Access Compliance Report

Public Rights-of-Way

(Curb Ramps)

Intersection ID: 23148	Main Street: ALEXANDER_RD	Cross Street: HARRISON_RD	Location: NW
ADA ID: 4BC370F84B05	Ramp Type: BlendTrans1	Initial Pass/Fail: Pass	Overall Compliance: No
Severity Score: 2.5			
Codes/Mitigation Info/Possible Solution		Field Measurements/Component Compliance

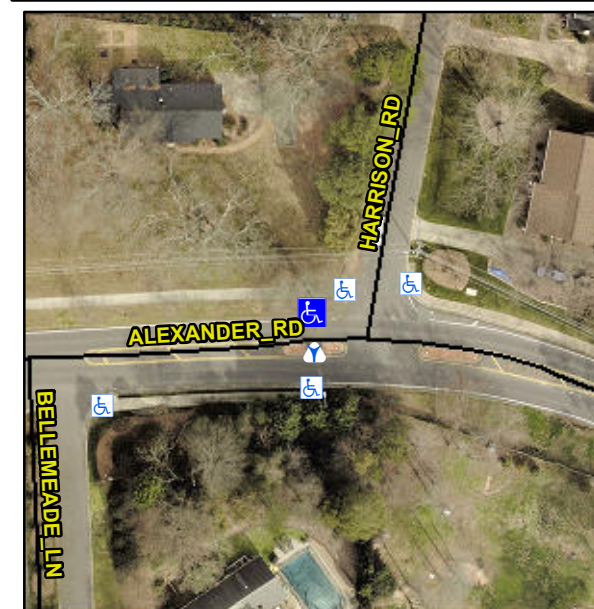
R304.2.2-Perp, R304.3.2-Para, R305.1.4

Remove & Replace Curb Ramp With Two New Directional Ramps or Equivalent.
